## HISTORIC AND DESIGN REVIEW COMMISSION

July 19, 2017

**HDRC CASE NO:** 2017-335  
**ADDRESS:** 422 SHERMAN ST  
**LEGAL DESCRIPTION:** NCB 514 BLK 18 LOT W 75 FT OF 13 HS ARB A 13  
**ZONING:** R-6, H  
**CITY COUNCIL DIST.:** 2  
**DISTRICT:** Dignowity Hill Historic District  
**APPLICANT:** Michelle McKenna  
**OWNER:** Michelle McKenna  
**TYPE OF WORK:** Porch modifications, exterior modifications, driveway, fencing and landscaping  
**REQUEST:**

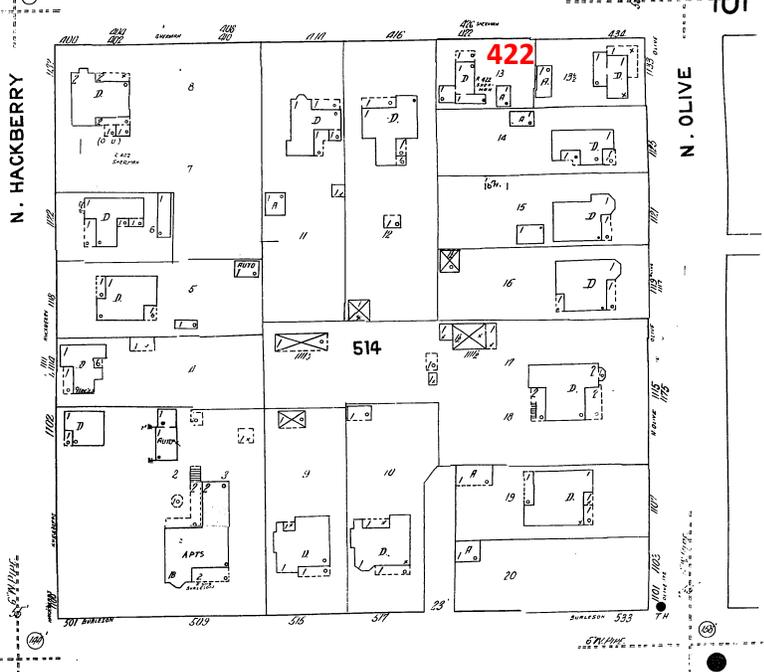
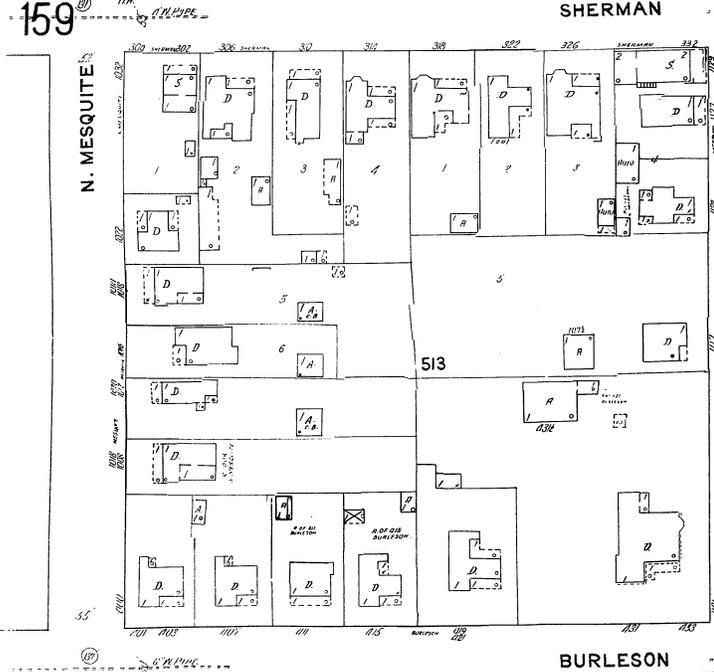
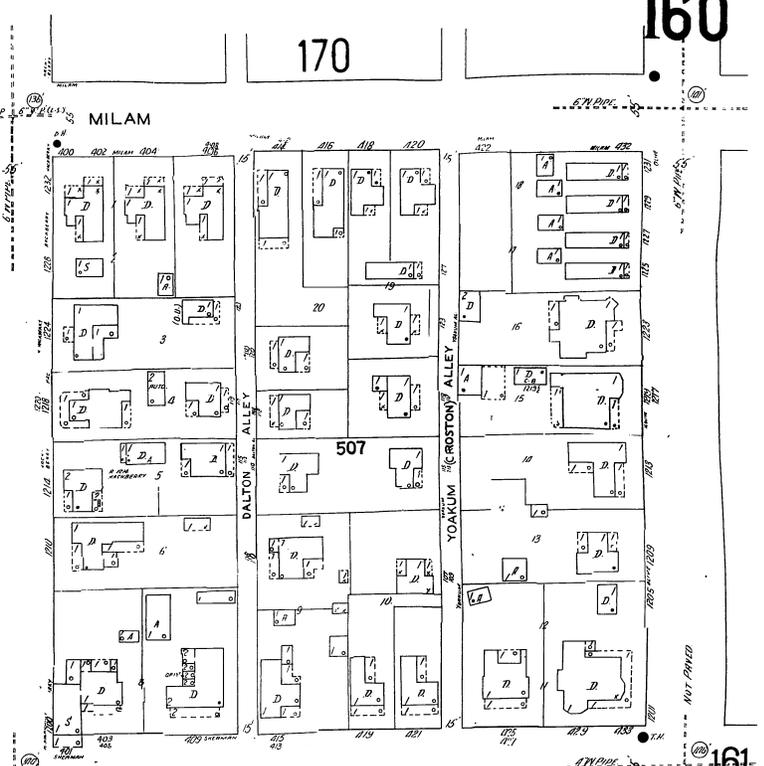
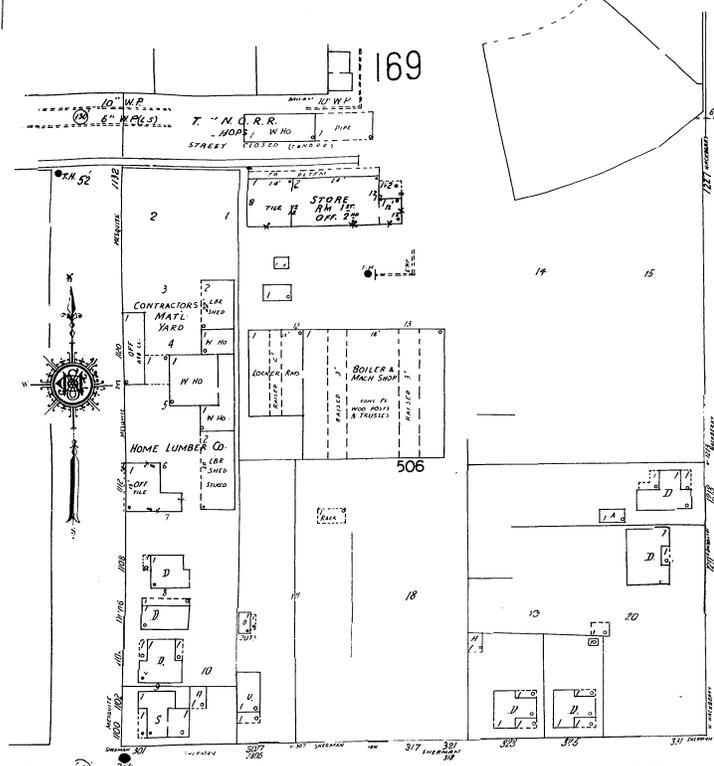
- g. DRIVEWAY – The property currently features a gravel driveway on the west side of the property that extends to an existing addition. The applicant has proposed to resurface the existing driveway with crushed black granite. The use of crushed black granite is not found in a historic context throughout the Dignowity Hill Historic District. The Guidelines for Site Elements 5.B.i. notes that historic driveway configurations should be maintained and that

- i. That the applicant install gravel or decomposed granite to match the existing or install brown decomposed granite as noted in finding h.
- ii. That the proposed driveway does not exceed its current width.

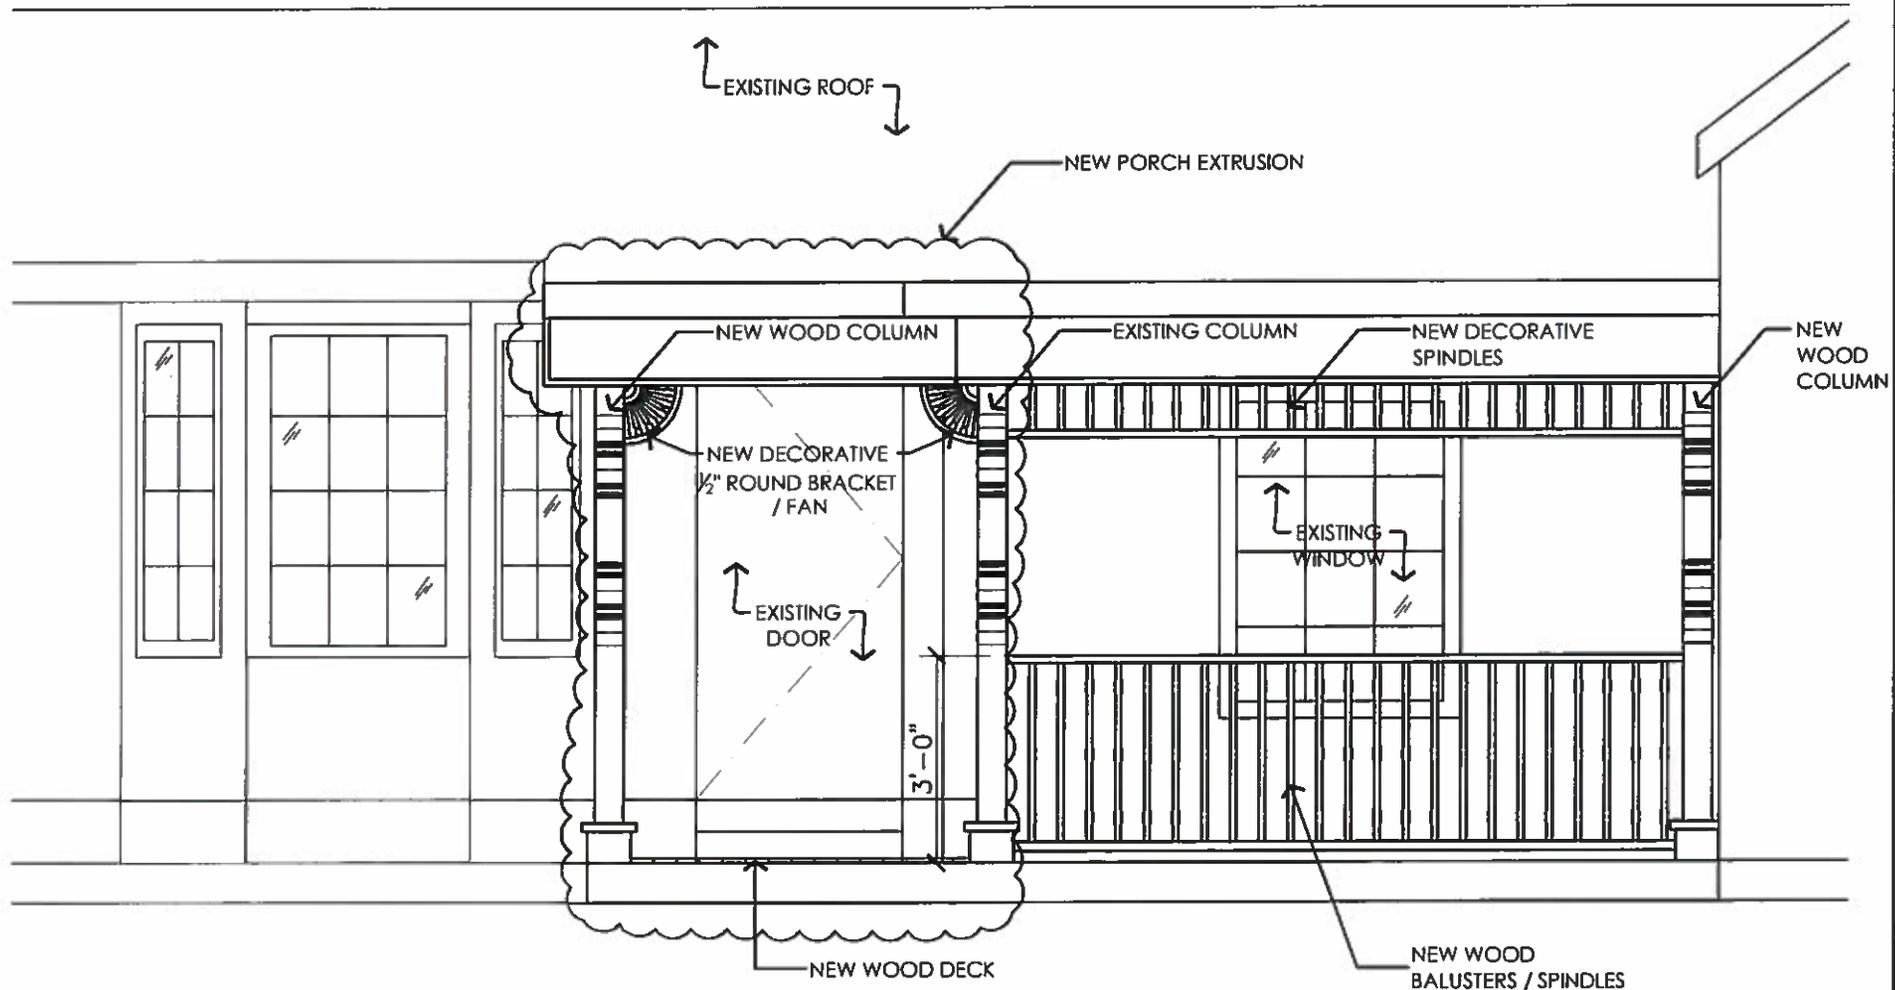
- b. PORCH EXTENSION – The applicant has proposed to extend the existing front porch to the west, across the façade of the side addition. The applicant has proposed for the porch extension to feature a roof which matches that of the existing as well as a porch slab to be consistent with the existing. Per the Guidelines for Exterior Maintenance and Alterations 7.B.v., new porches should be based on the architectural style of the building. Regarding massing, the proposed porch is consistent with the Guidelines; however, the applicant has proposed decorative spindle work and brackets that presents a false sense of history and is inconsistent with the Guidelines for Exterior Maintenance and Alterations 7.B.iv. Staff finds that the applicant should eliminate the proposed decorative spindle work and brackets from the proposed porch to become consistent with the Guidelines.

- c. NEW DOOR – To the right of the existing bay window, the applicant has proposed to install a new, street facing entrance door. Per the Guidelines for Exterior Maintenance and Alterations 6.B.ii., new entrances should be compatible in size, scale, shape, proportion, material and massing as historic examples. Staff finds the proposed location appropriate given the non-original nature of the portion of the structure where it is proposed.

- i. That the applicant eliminate the decorative spindle work and brackets that create a false sense of history as noted in finding b.
- ii. That the proposed front yard, wood picket fence does not exceed four (4) feet in height as noted in finding f.

SHERMAN HOUSE

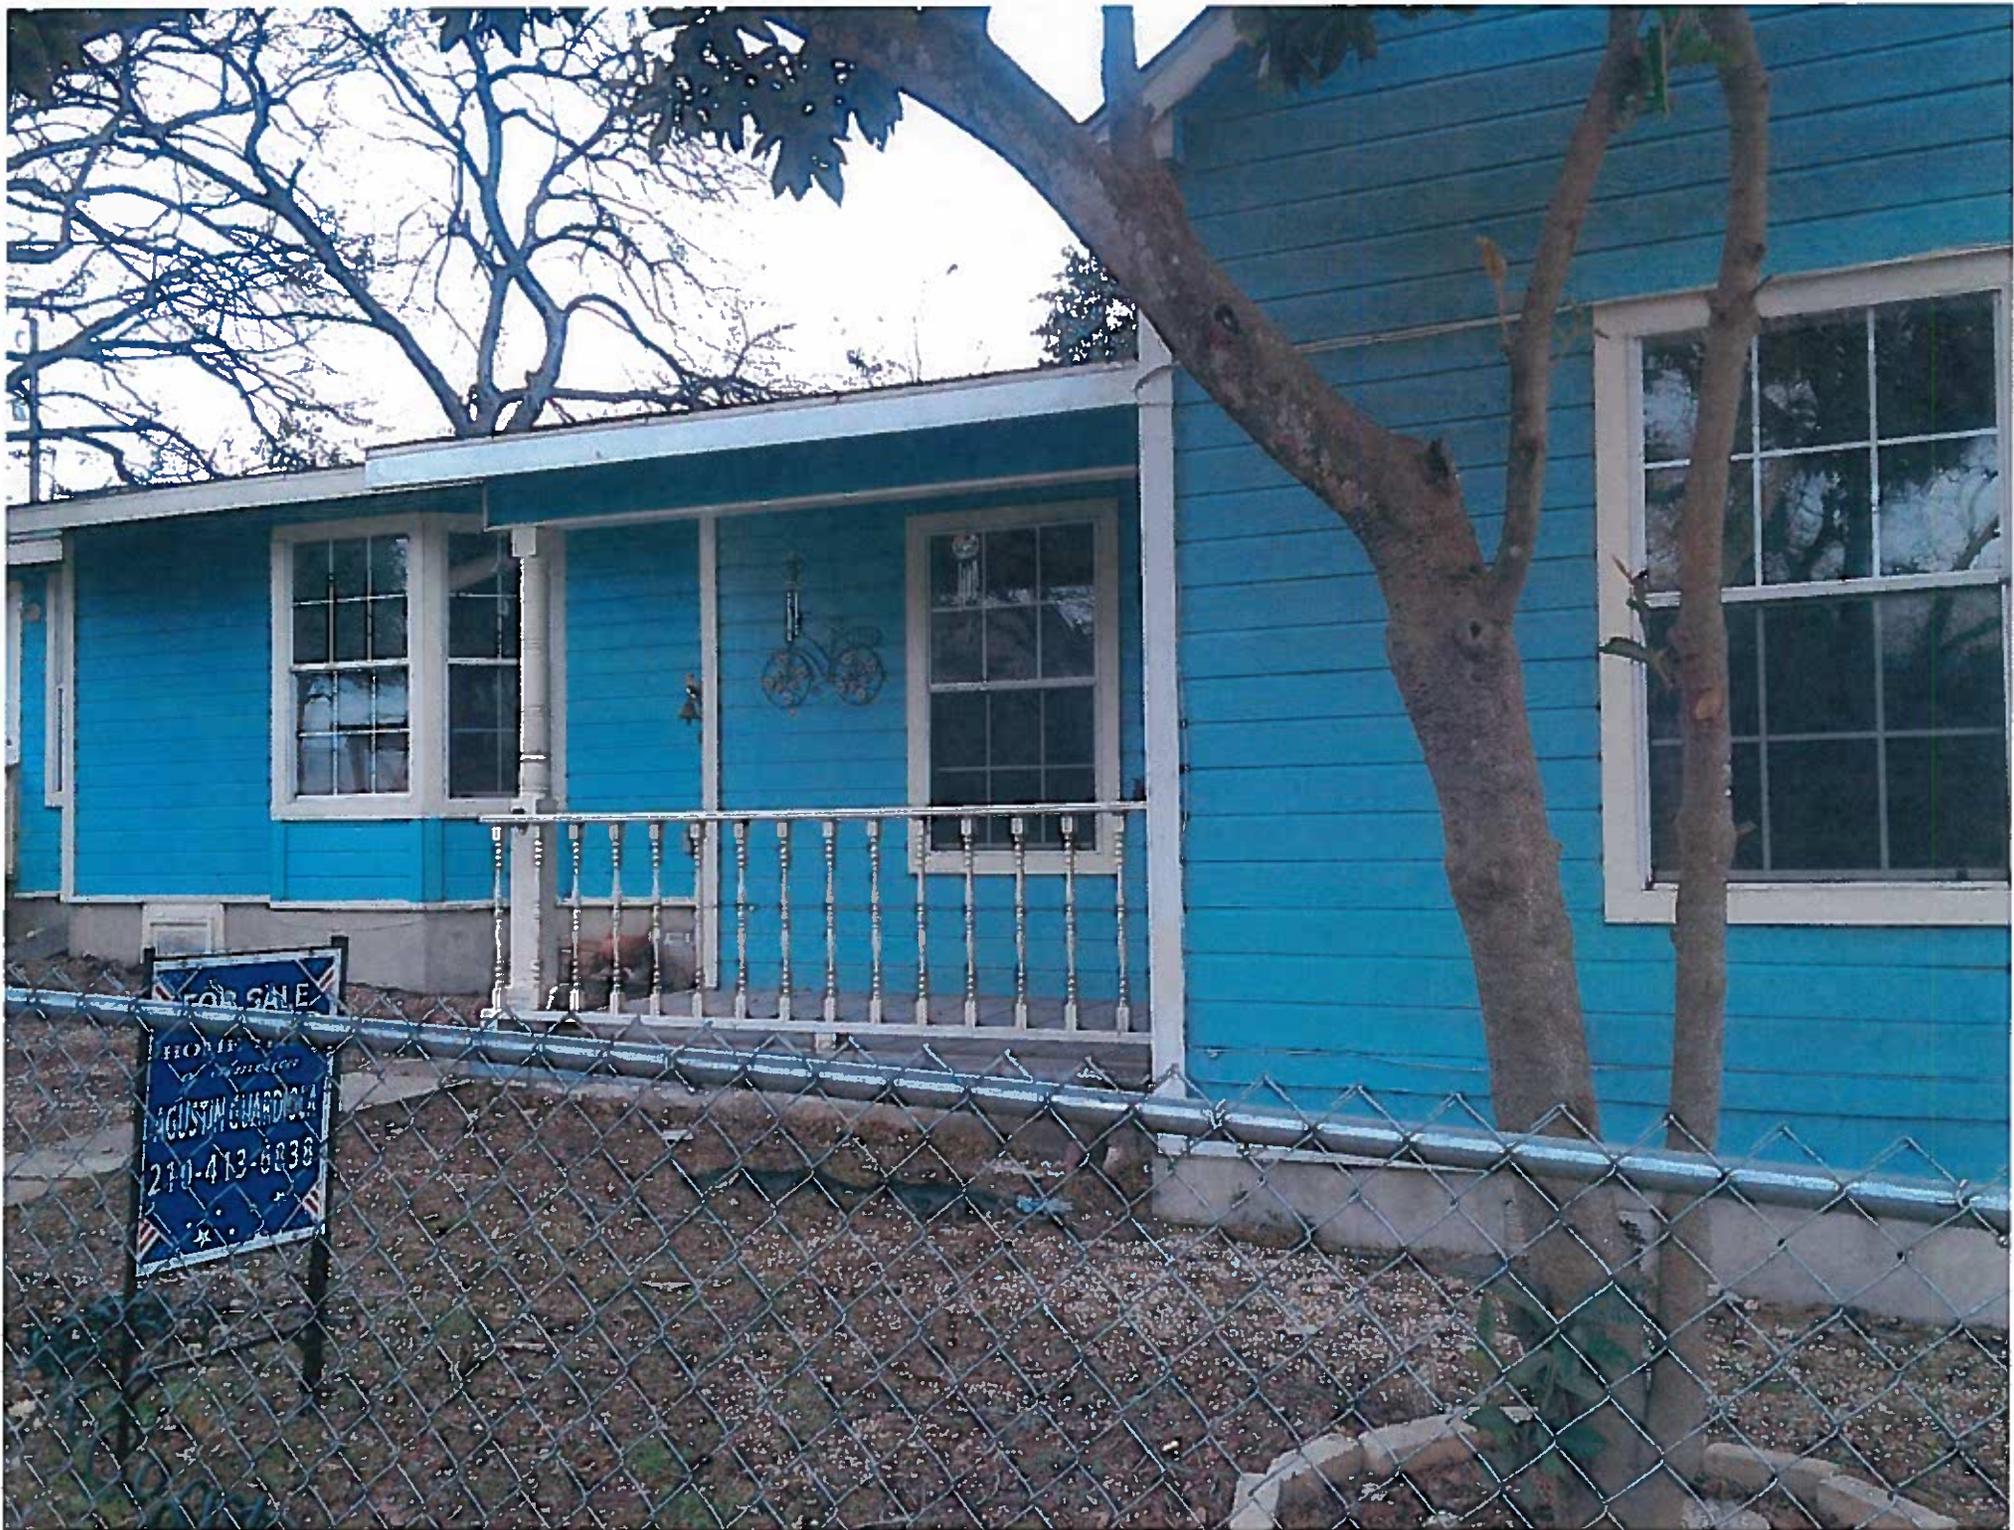
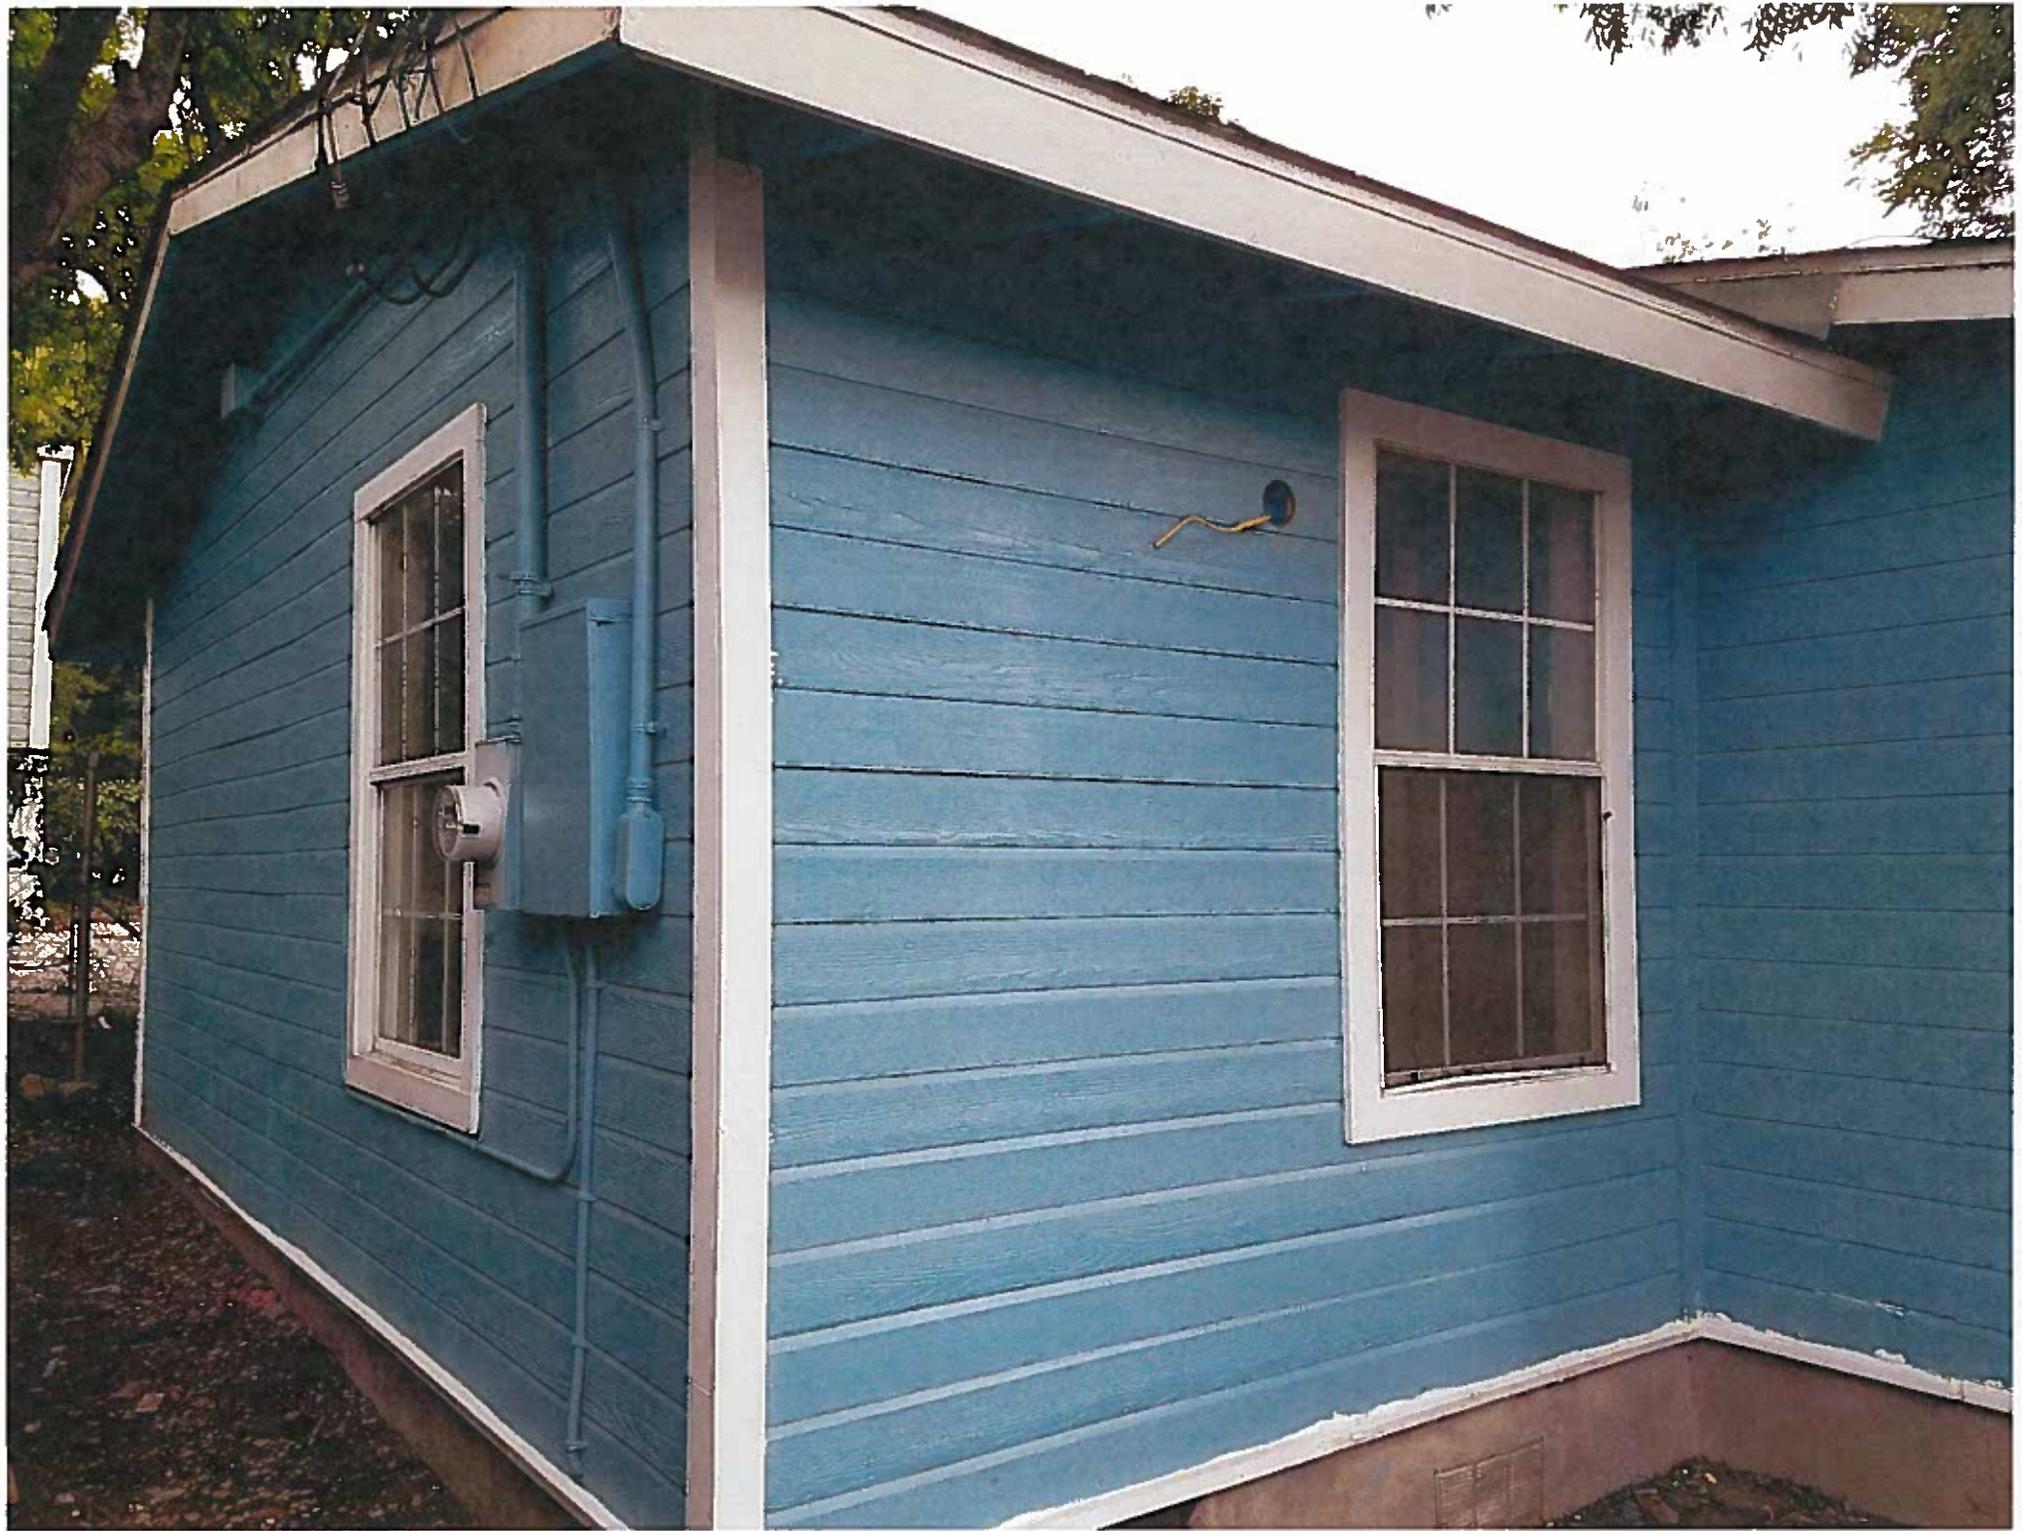
- e. FENCING – The applicant has proposed to replace the existing chain link fence with a new, wood picket fence. Per the Guidelines for Site Elements, 2.B., new fences should appear similar to those used historically within the district in terms of their scale, transparency and character. Additionally, the design of new fences should respond to the design and materials of the house or main structure. Staff finds the proposed fencing appropriate and consistent with the Guidelines. The height of the front yard fencing is not to exceed four feet in height.
